Final Set, Jefferson Village Phase II  
(Bulletin 6)

JEFFERSON VILLAGE

TYPICAL PAVEMENT CROSS SECTIONS

HOR. SCALE: NO SCALE  
VER. SCALE: NO SCALE  
DATE: 3-27-00  
JOB NO.: DE99011  
FILE NO.: DE9911X1  
SHEET NO.: P-0.2

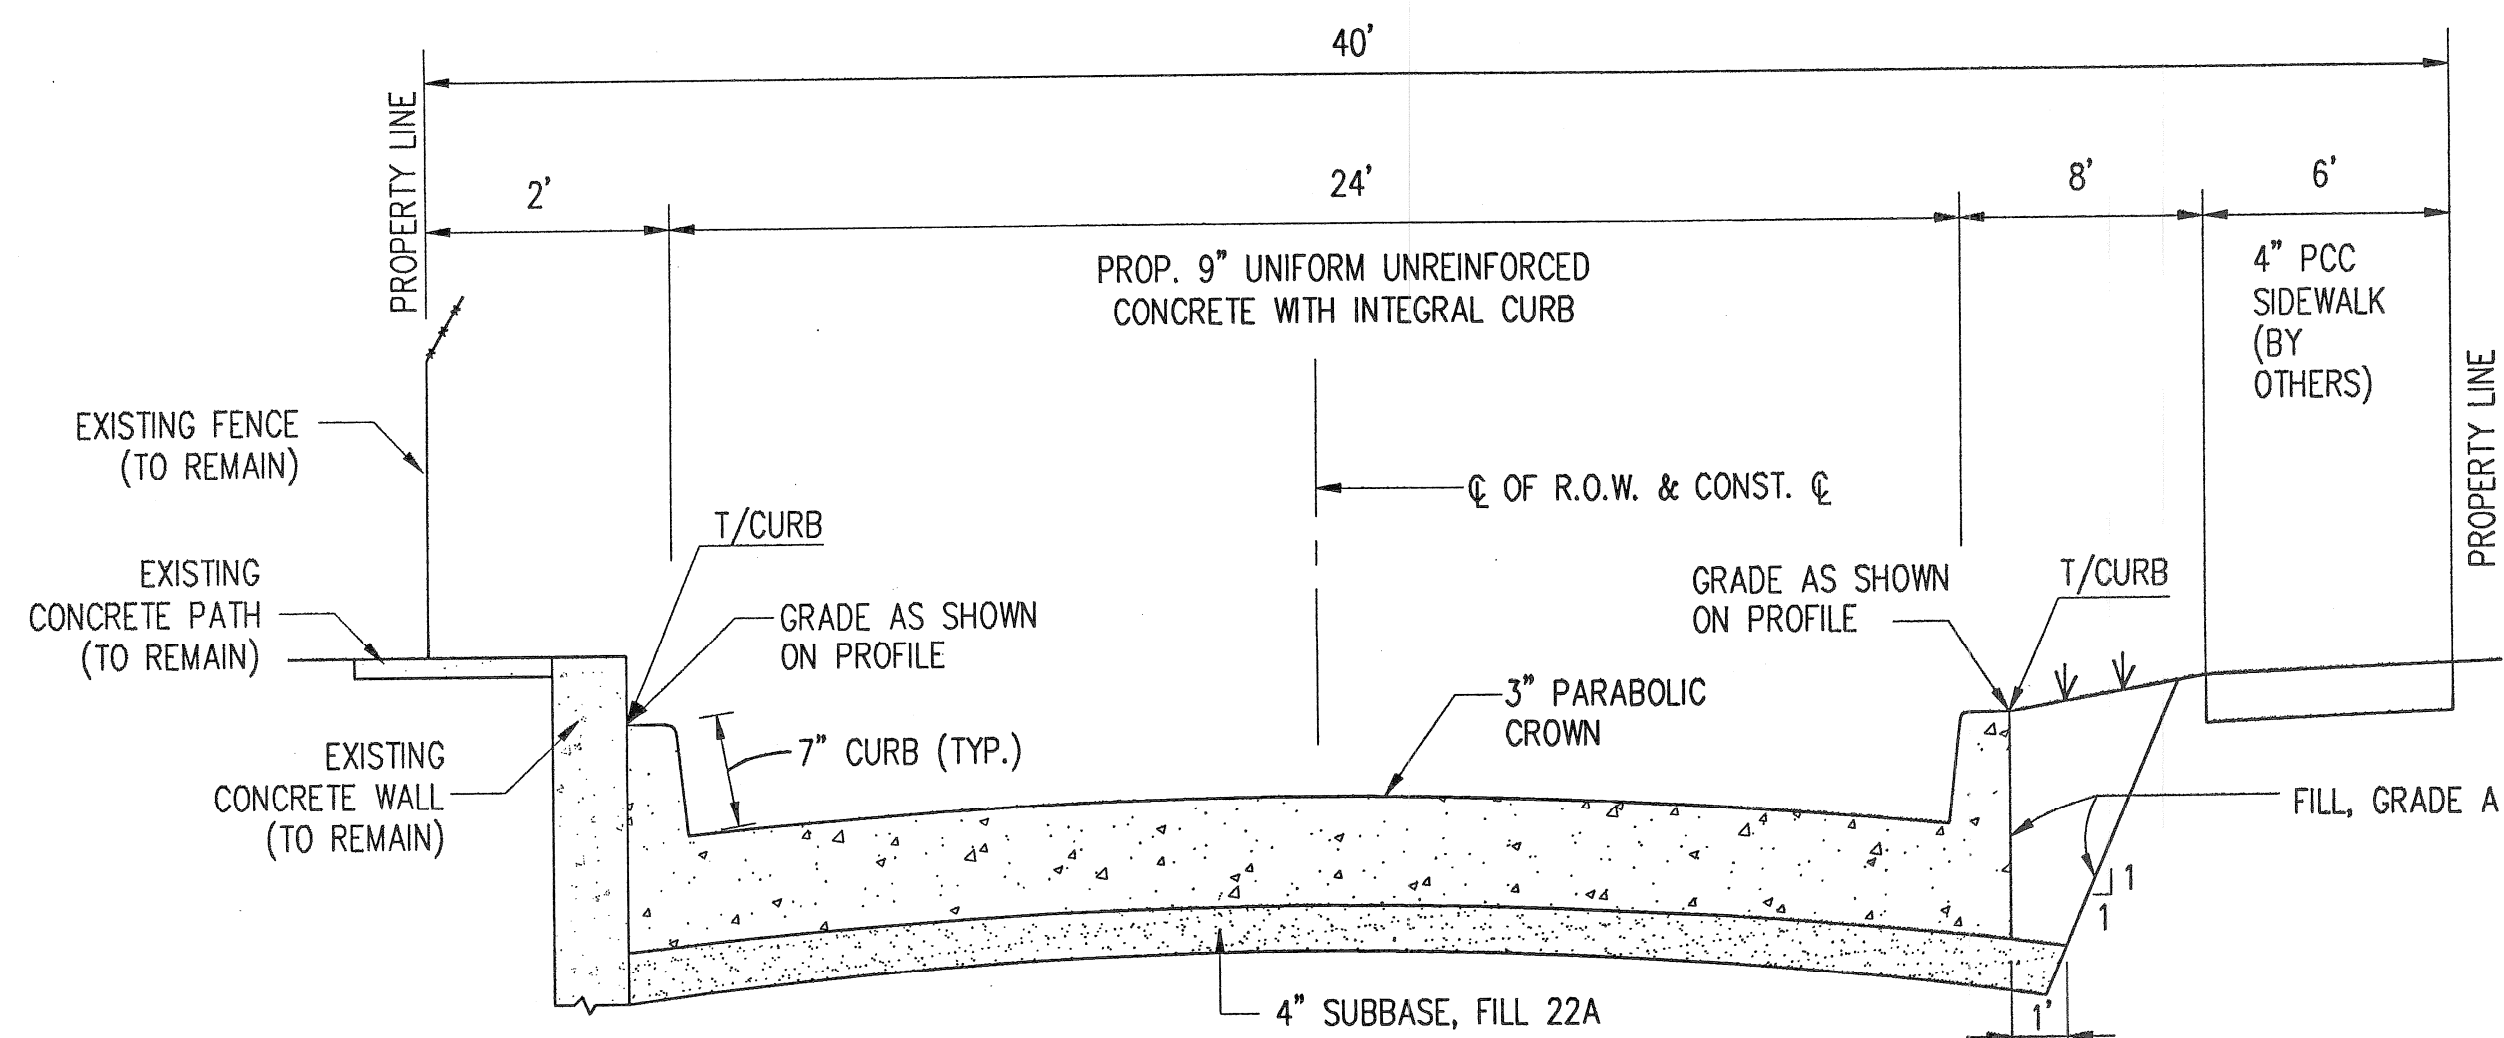
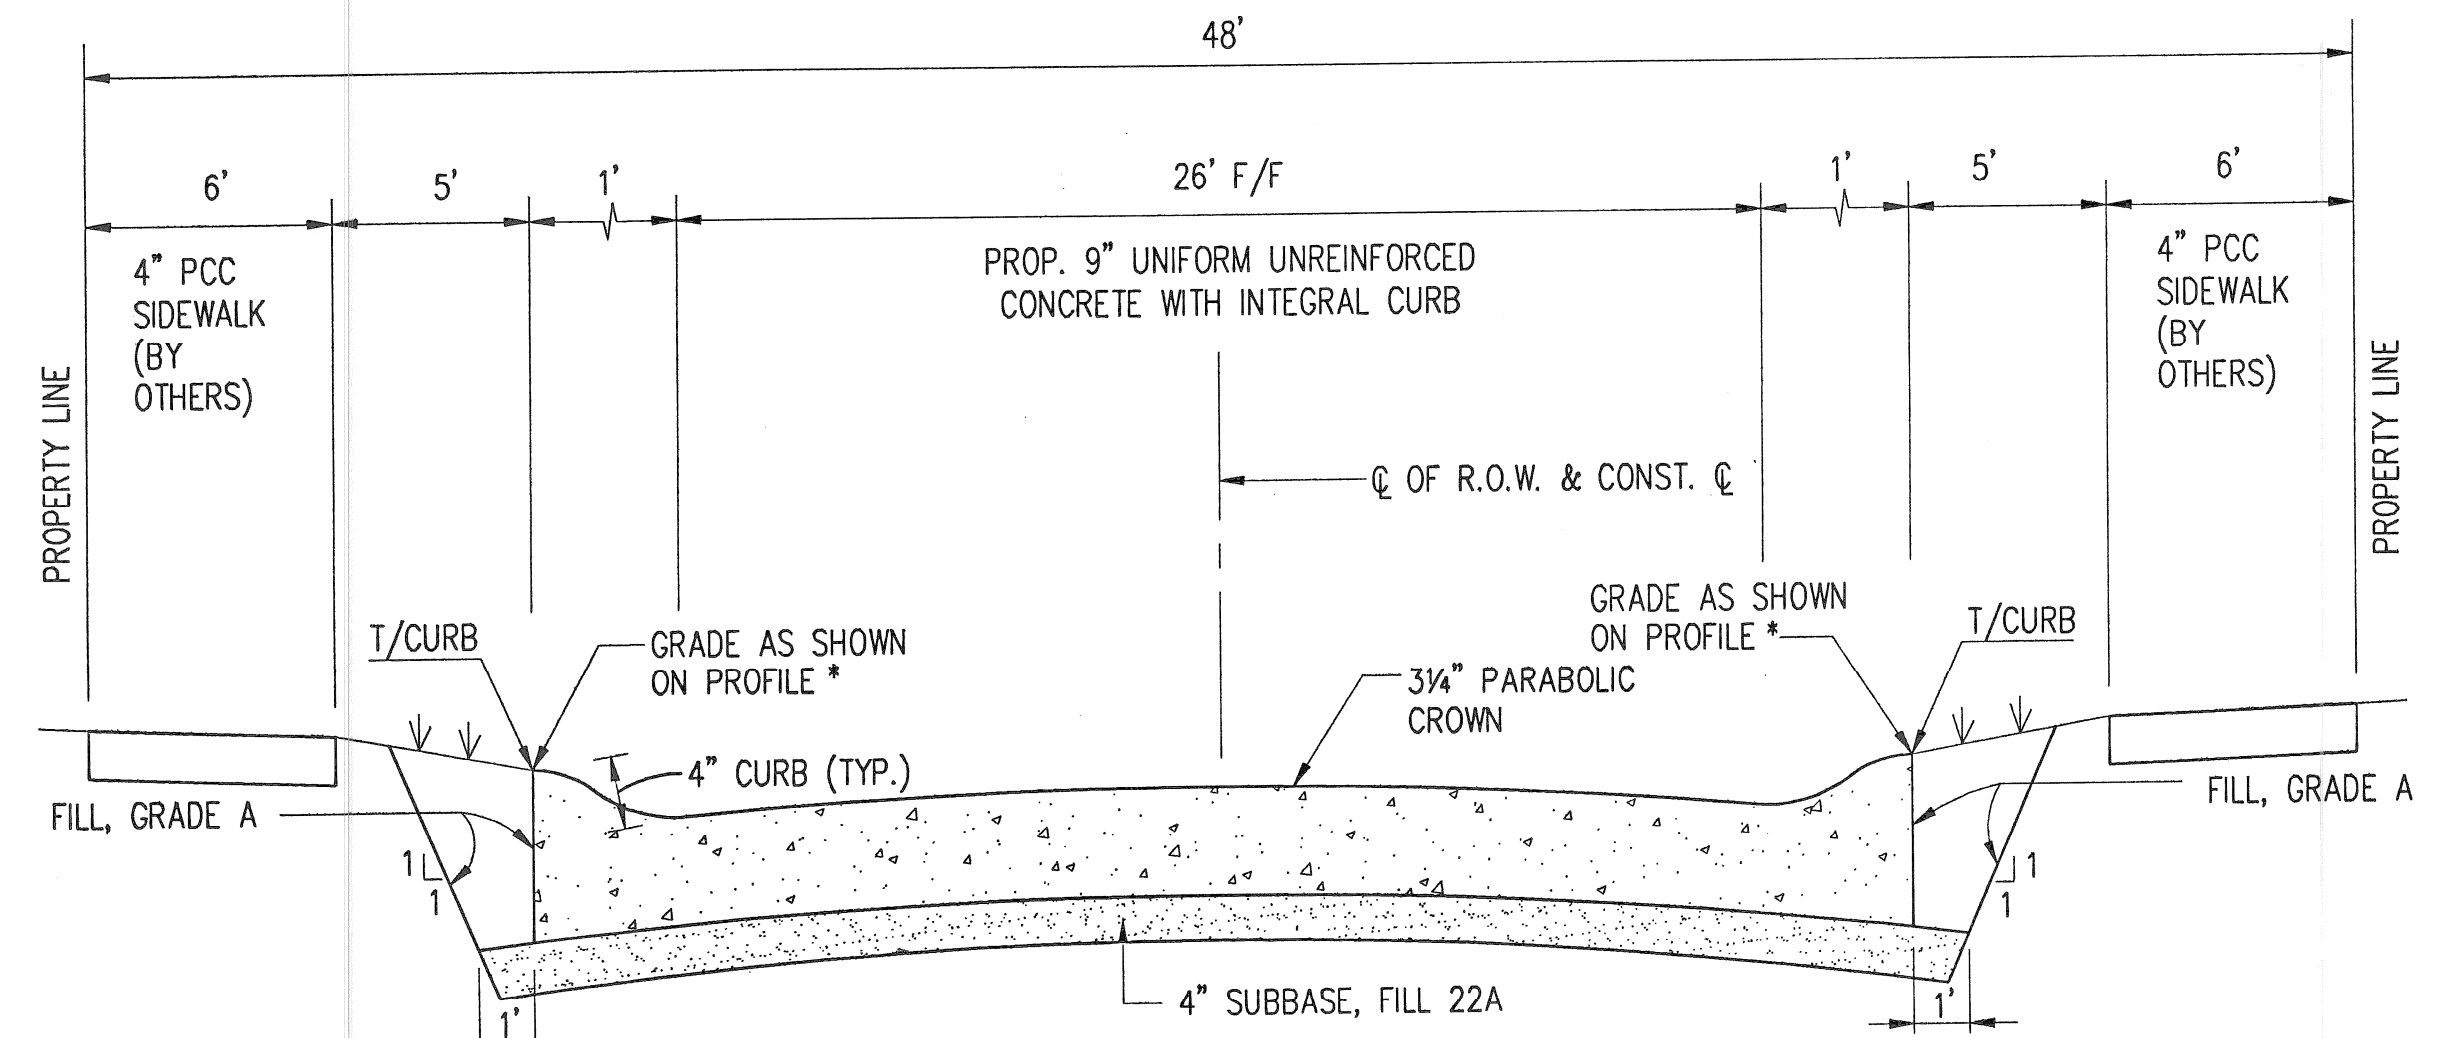
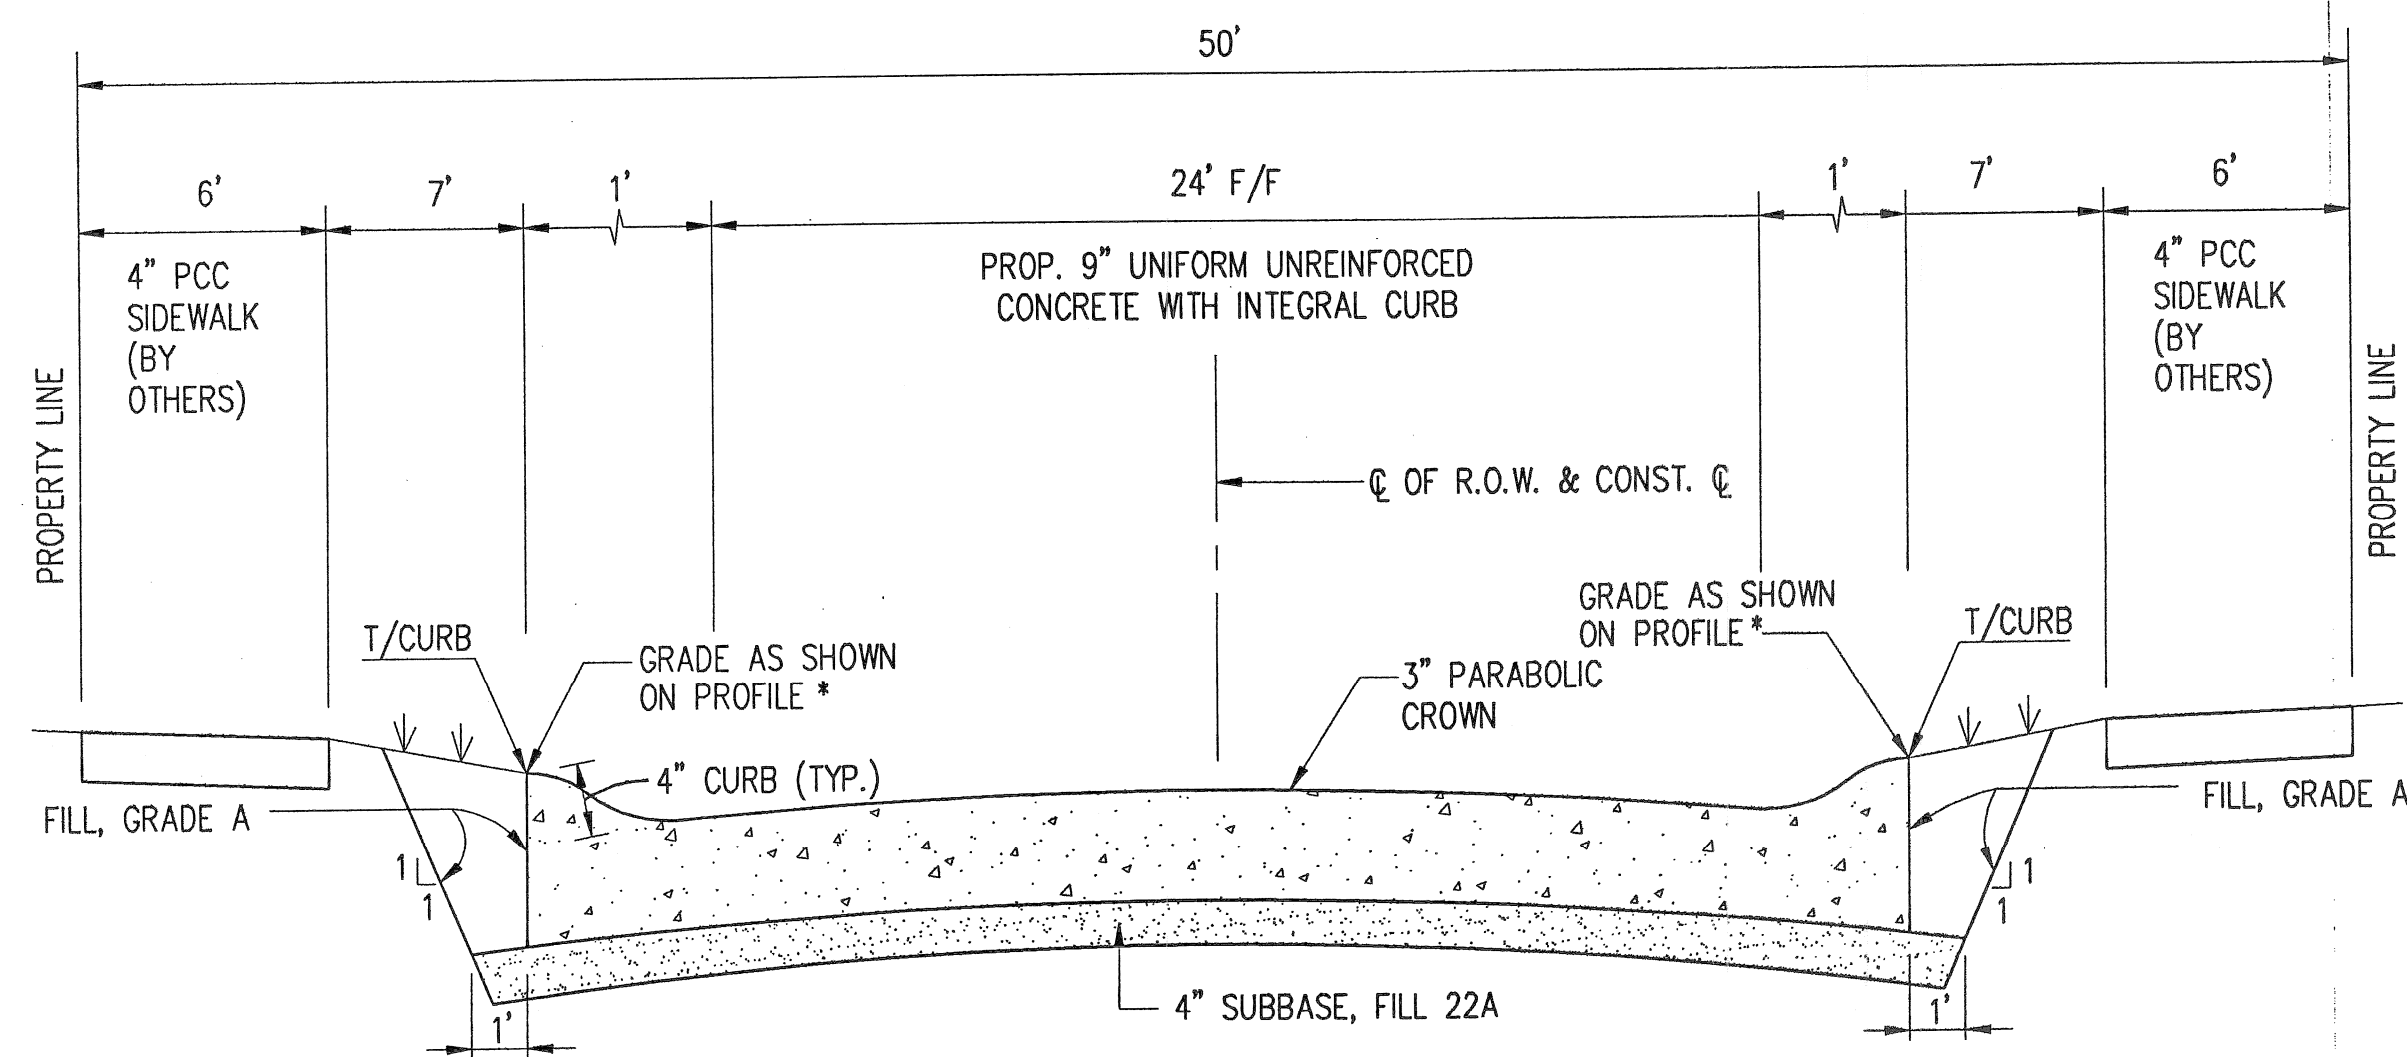
\* THE TYPE OF CURB WAS CHANGED FROM 7" HIGH STRAIGHT  
FACE TO 4" HIGH ROLLED CURB AFTER THE PREPARATION  
OF THE PAVING PLANS AND PROFILES (EXCEPTING FOR FREUD, MARQUETTE  
AND NEW STREET BETWEEN BENITEAU AND ST. JEAN). THE PAVEMENT  
ELEVATIONS AS SHOWN ON THE INTERSECTION DETAILS SHEETS SHALL BE  
MAINTAINED. ONLY THE TOP OF CURB ELEVATIONS SHALL BE DROPPED BY  
0.25' (3"). THIS SHALL BE ACHIEVED BY SUBTRACTING 0.25' (3") FROM THE  
TOP OF CURB ELEVATIONS SHOWN ON THE PROFILES.
